TO: Town of Parker Recreation Dept.
FROM: Julia Duncan, Associate Planner
DATE: January 23, 2025
SUBJECT: SP24-124; Salisbury North MDP F1 AMD 2 L1 - Park Expansion Phase 1
Review Comments 01

SALISBURY PARK NORTH PHASE 1

TOWN OF PARKER SITE PLAN

A1 OVERALL SITE AND PHASING PLAN
 1" = 140'-0"

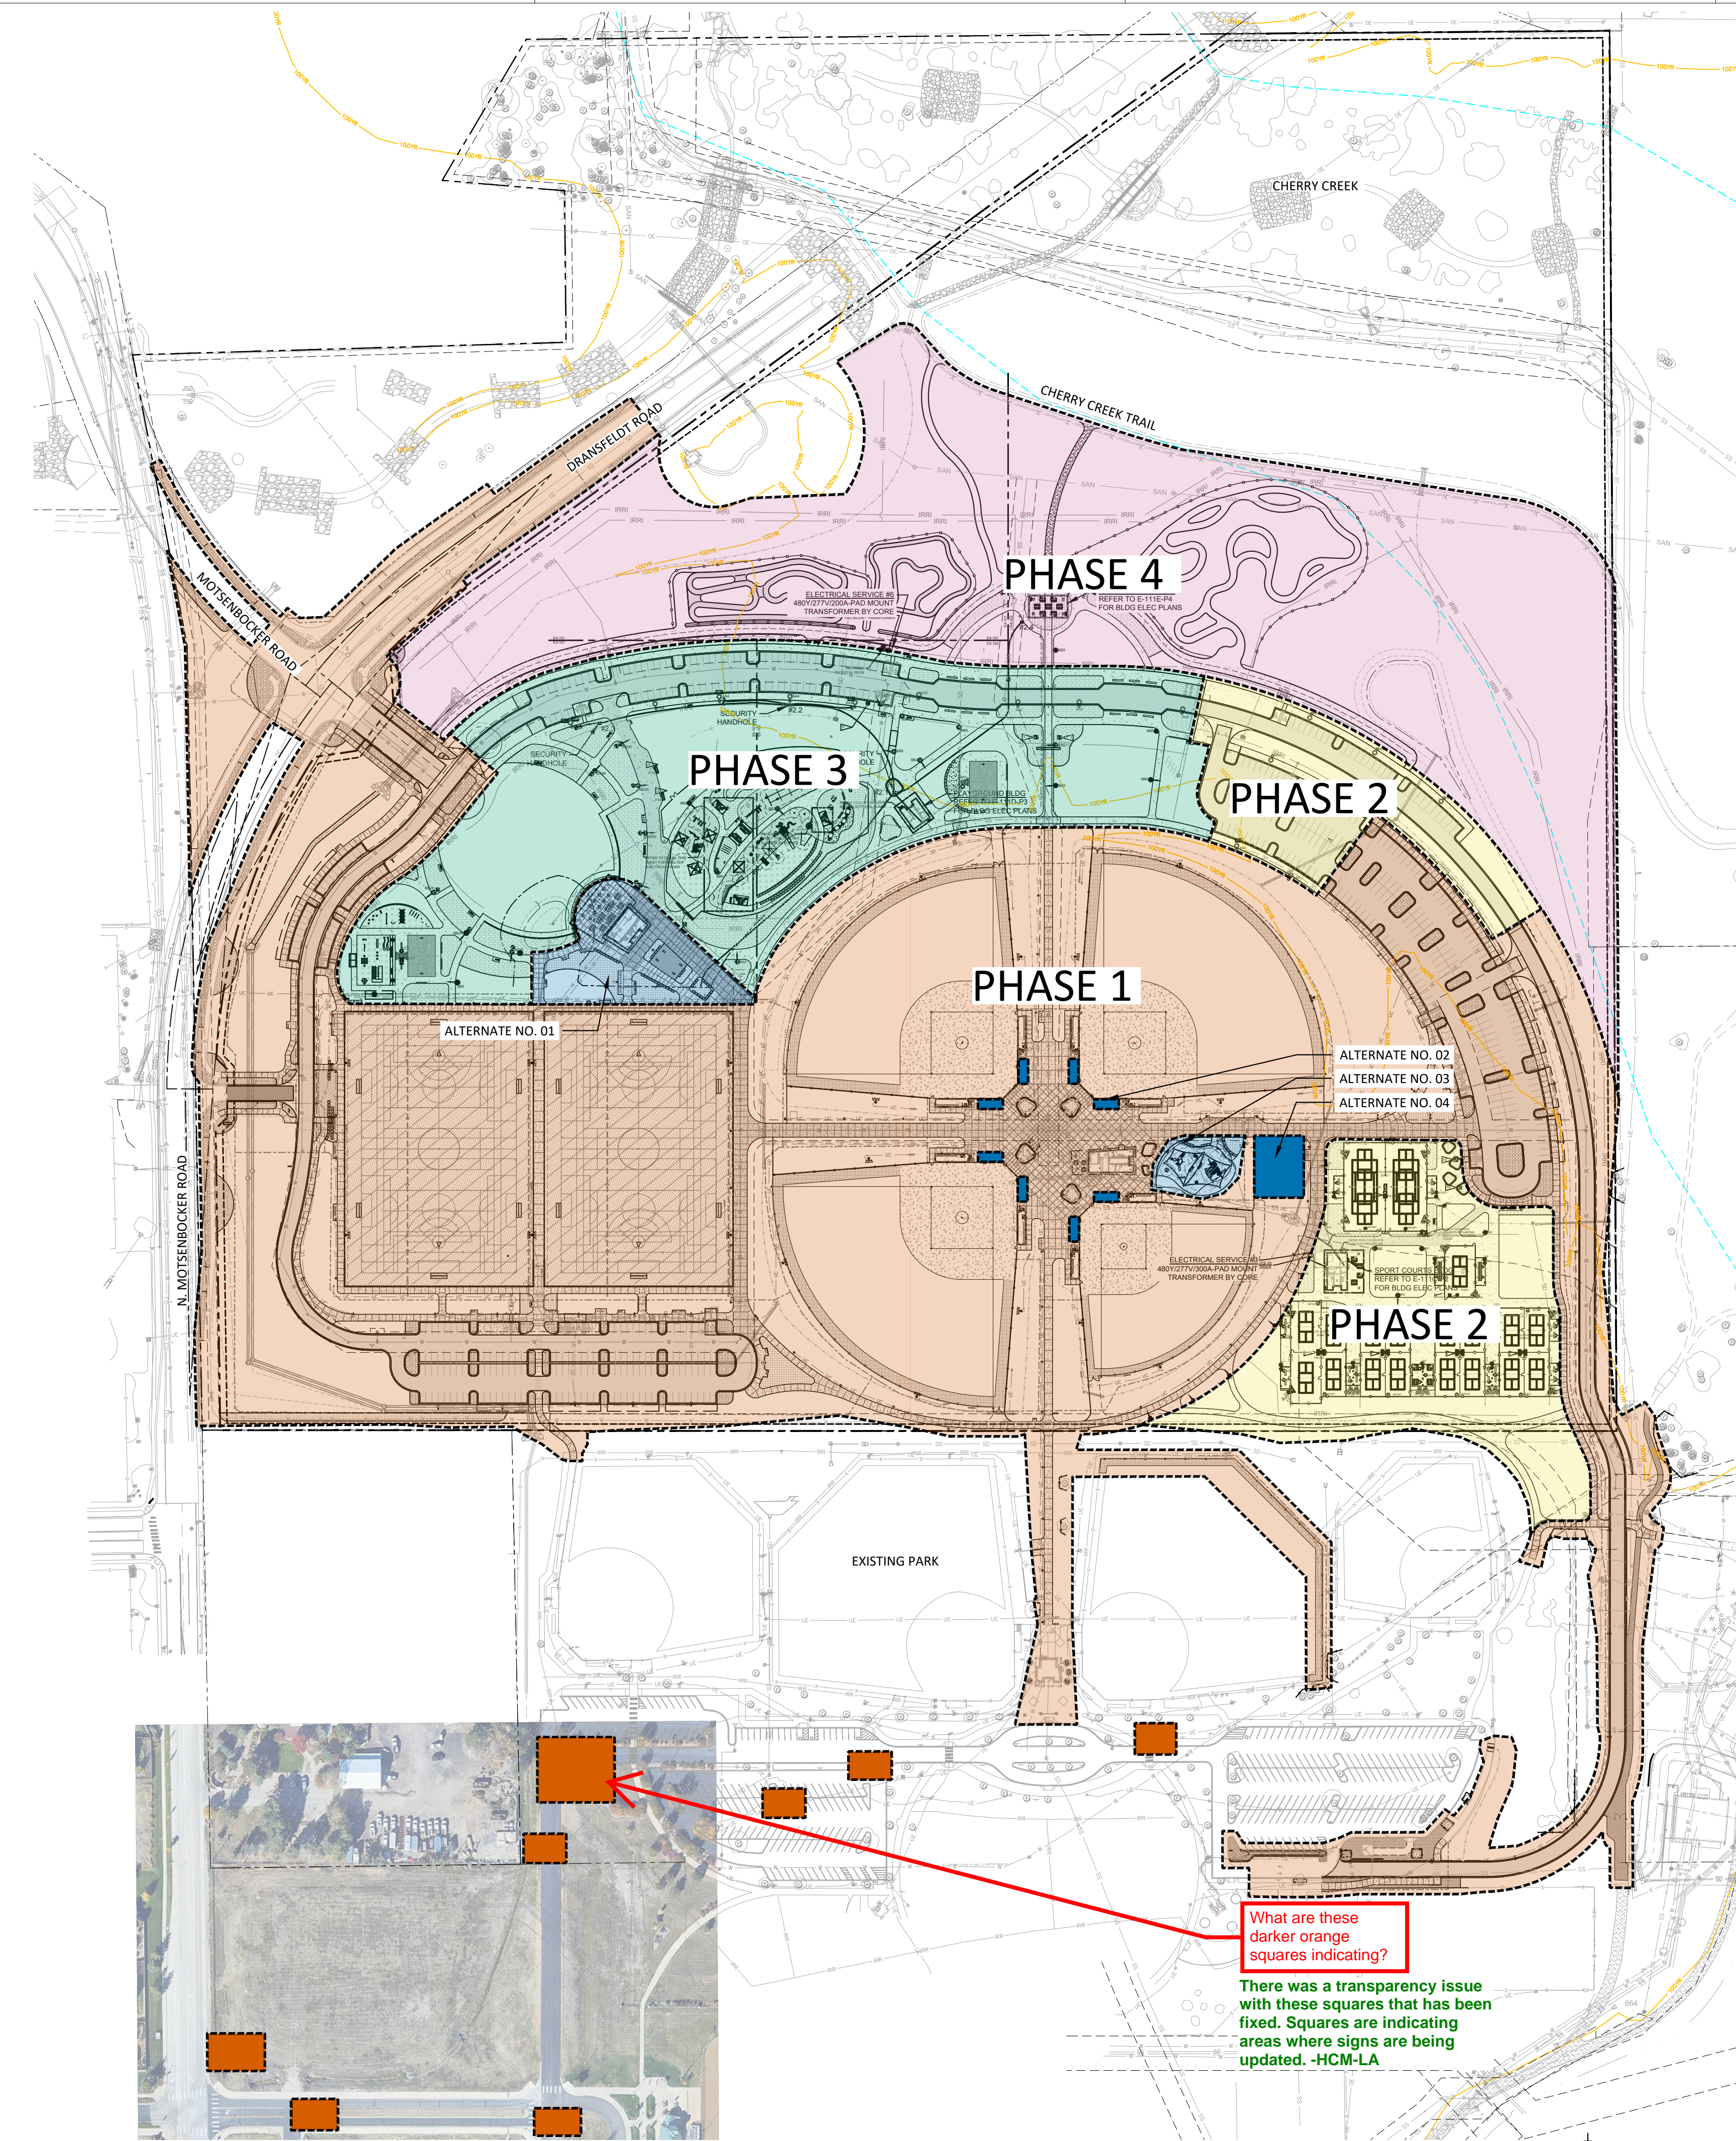
What are these darker orange squares indicating?

There was a transparency issue with these squares that has been fixed. Squares are indicating areas where signs are being updated. -HCM-LA
